**From:** Nagel, Peter <PNagel@bwbr.com>  
**Sent:** Thursday, June 9, 2022 2:53 PM  
**To:** Johnson, Nick M; kari.davis@mcgough.com; Roisen, Nathan  
**Subject:** RE: Seagate Full Permit - #PRBD202205931 - 7801 Computer Ave S and 7850 Nord Ave S  
**Attachments:** 900.L4 - ELECTRICAL SITE PLAN WEST - INITIAL LIGHTING CALCS.pdf; 900.L5 - ELECTRICAL SITE PLAN WEST - MAINTAINED LIGHTING CALCS.pdf; 900.L2 - ELECTRICAL SITE PLAN - INITIAL LIGHTING CALCS.pdf; 900.L3 - ELECTRICAL SITE PLAN - MAINTAINED LIGHTING CALC.pdf

**Subject:** Seagate Full Permit - #PRBD202205931 - 7801 Computer Ave S and 7850 Nord Ave S

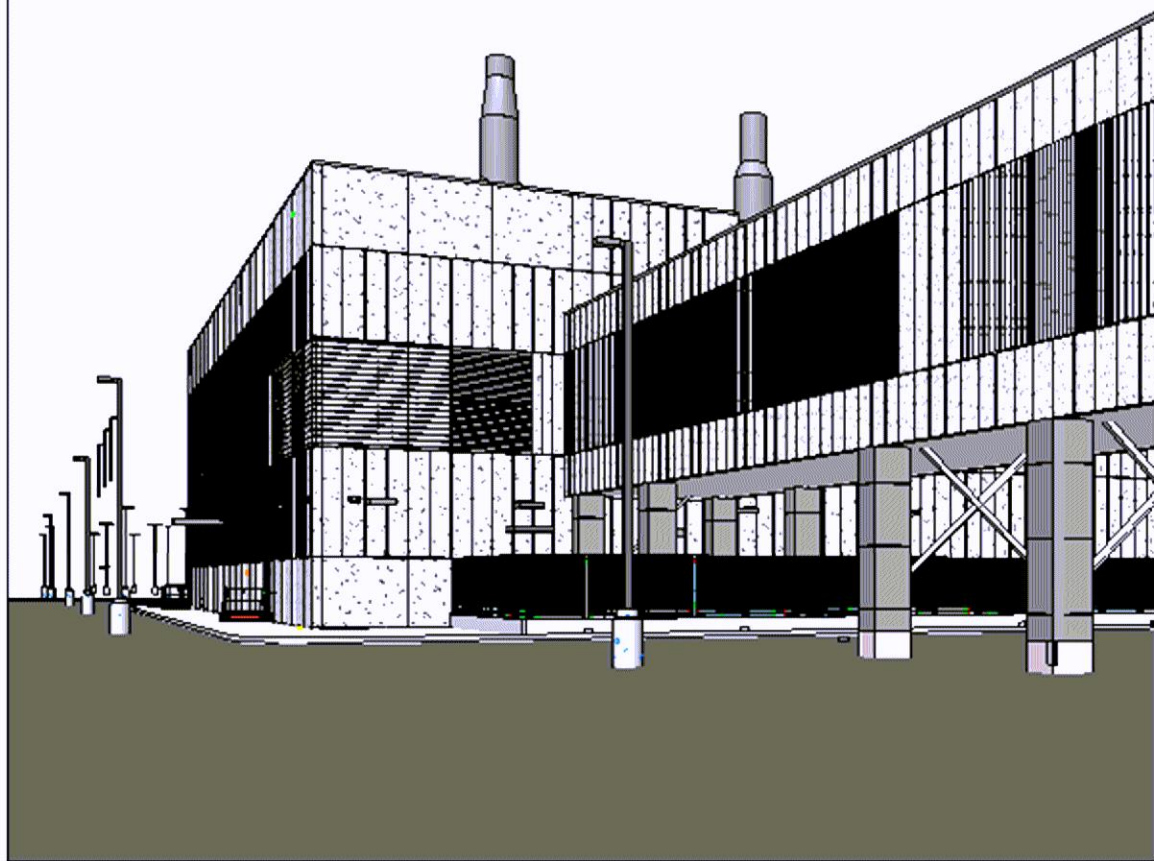
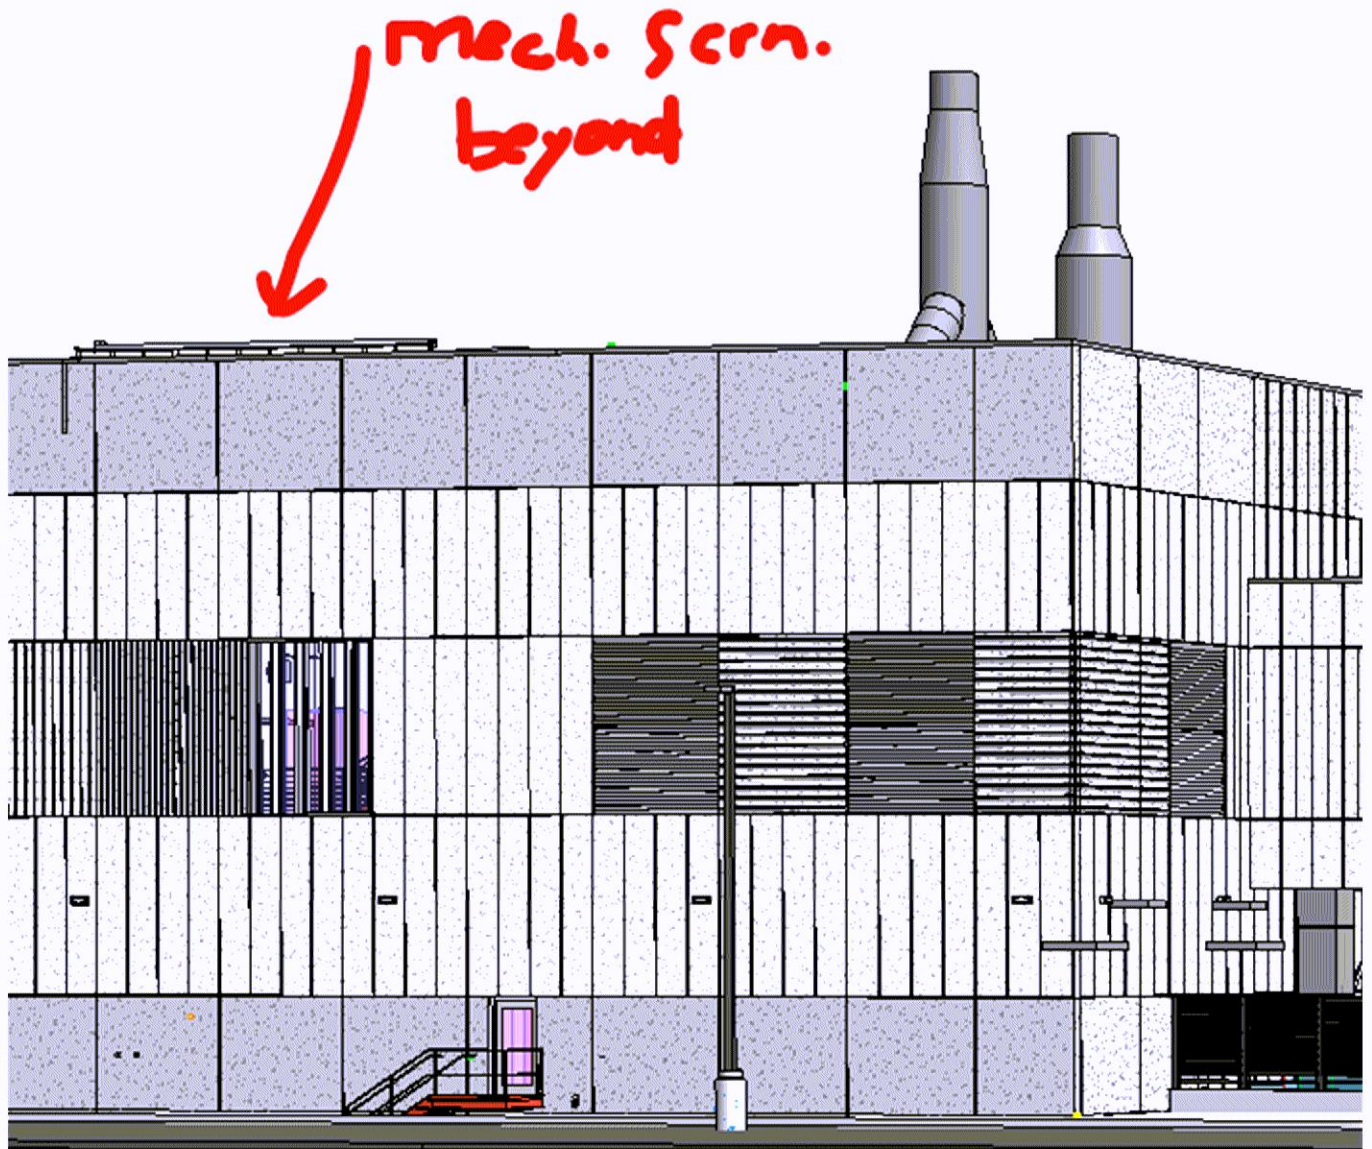
The rooftop area to the east of this equipment includes the mechanical exhaust chimneys. So long as these are coated to a neutral color (say gray or light blue), we have not required these be screened. However, it appears that there is some associated mechanical equipment in and around the chimneys that likely would meet the criteria of equipment that is needed to be screened. I have highlighted this equipment I am referring to here:

Is it possible to screen this equipment with a lower metal parapet of some kind? It does not look that tall. Or can you verify that this equipment will not be visible from the ground on adjacent public and private streets and sidewalks?

1. Yes, we did prepare updated photometric plans. They were a part of the building plans uploaded but I have reattached for your convenience.
2. The view you're seeing is kind of misleading...from a straight on elevation, it looks like the equipment is not that tall, but we actually raised the parapet there 15' above the roof deck (to the maximum allowable building height of 55'-0") solely to screen that equipment – see snip below which is looking southeast from the roof. Even with that 15' parapet, it does still pop up a little bit in a straight-on view, because as the design has evolved we have found that some of the equipment requires platforms, but we are confident that nothing (other than the stacks) would be visible from ground level. Below are views from the right-of-way from the southeast, and from W 78<sup>th</sup> St to the south.
